**Massing improvements – Gould Road & Crane Road (DRP comment)**

### Summary of elevation and massing amendments to Building F following DRP & pre-application

2.4 Environmental agency & Friends of the River Crane comments

**Massing improvements – Gould Road & Crane Road (pre-application comment)**

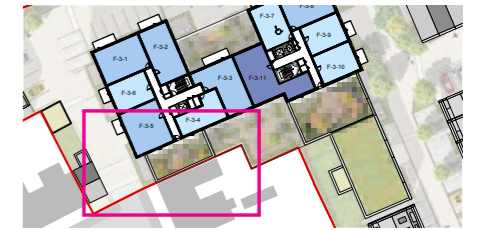
- Concerns over the massing at the junction of Gould Road and Crane Road in relation to existing terraces and overlooking from the roof gardens in Building F;
- Review the lantern roof and look at the option of a flat roof instead; not convinced of the darker tone.

- The roof of Building F appears over-heavy and appears to emphasise the upper-storey finish.

**Overlooking & privacy**

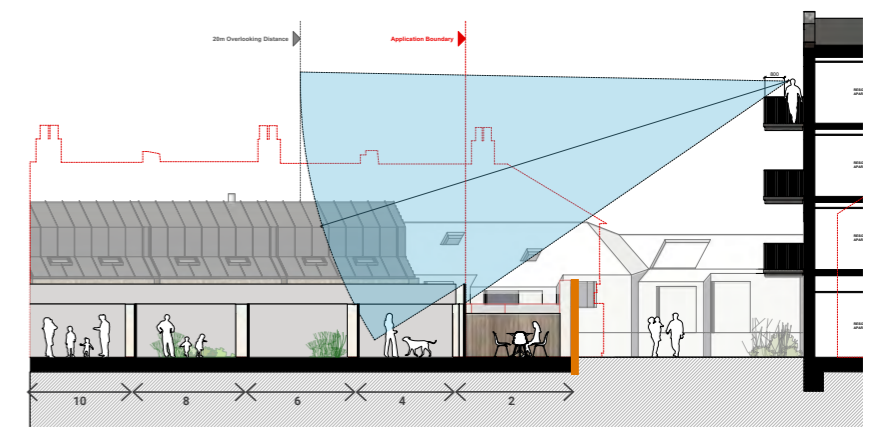
Fourth Storey and balconies to the western end of Building F could have a negative impact and potential overlooking.

A full review of overlooking was undertaken on these properties. The current proposal does not overlook existing windows, but does overlook their gardens. Overlooking of gardens is a common condition within the area and not considered unacceptable, whilst it is important new apartments are provided with balconies to meet New London Plan Guidance.

However the following changes are proposed to reduce this perceived overlooking to benefit the existing owners of the gardens.

- Overlooking to neighbouring gardens minimised by garden of number 2 Gould Road and proposal to increase height of existing perimeter wall at site application boundary;
- Balcony railings amended to blades directing views towards the river providing residents with additional privacy and reducing overlooking from those sitting on the balcony or within the rooms.

Lux level analysis from lighting report

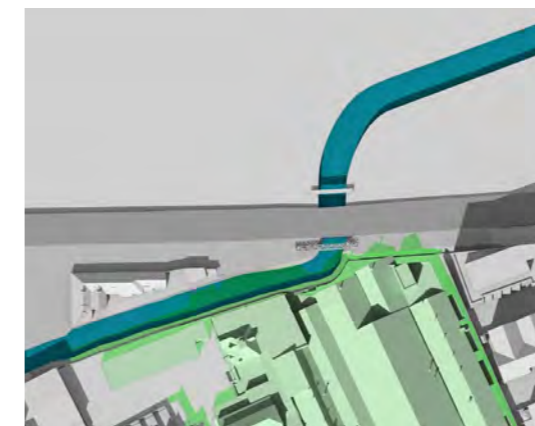
The plans proposed as part of this scheme make note of a sensitive lighting plan that is suitable for light sensitive species such as bats that are known in the area. We support the plan to use such lighting schemes however we feel that the lighting is still encroaching on the river corridor and channel. Light spill could be better prevented through the use of a natural corridor as a screen for the river.

We are concerned that the proposed development – in particular the 5-storey blocks facing the river – will increase light spillage into the corridor. Large accommodation blocks adjacent to the river will inevitably lead to extensive light pollution along what is currently a dark corridor used extensively by bats. The development proposed has a detrimental impact on the environmental value of the river corridor in terms of lighting, noise, shading and littering for example.

An Exterior Lighting Assessment Supplementary Report has been prepared by Desco, in consultation with the Project Ecologists.

This sets out that illuminance from the proposed development do not significantly impact the river 'Dark Corridor' and improve upon the existing conditions, where factory windows are directly on the river edge and factory noise would also have been present.

The proposals have been further enhanced by the introduction of a low level wall, railings, tree planting and hedgerow to the river edge, which will further protect the river corridor from light encroachment.

Existing 01:00pm

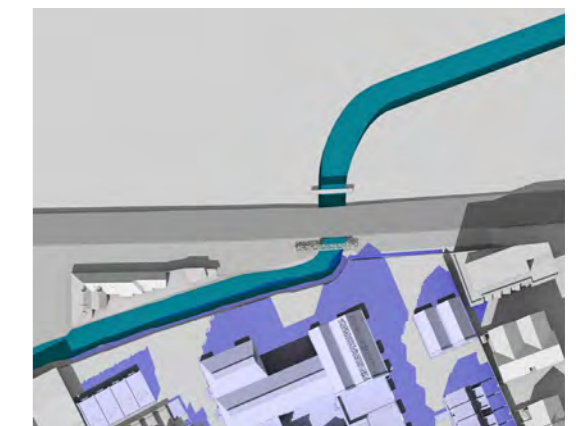
Overshadowing of the river corridor – particularly given the development is directly to the south of the river and will cast a significant physical shadow into the corridor, reducing its environmental potential.

An analysis has been undertaken on the levels of overshadowing comparing the existing condition and our proposed which demonstrates that there will be less overshadowing of the river with the new proposal. This is due to the buildings being significantly set back from the river edge when compared to the existing factory buildings, whilst large areas adjacent to the river go completely undeveloped.
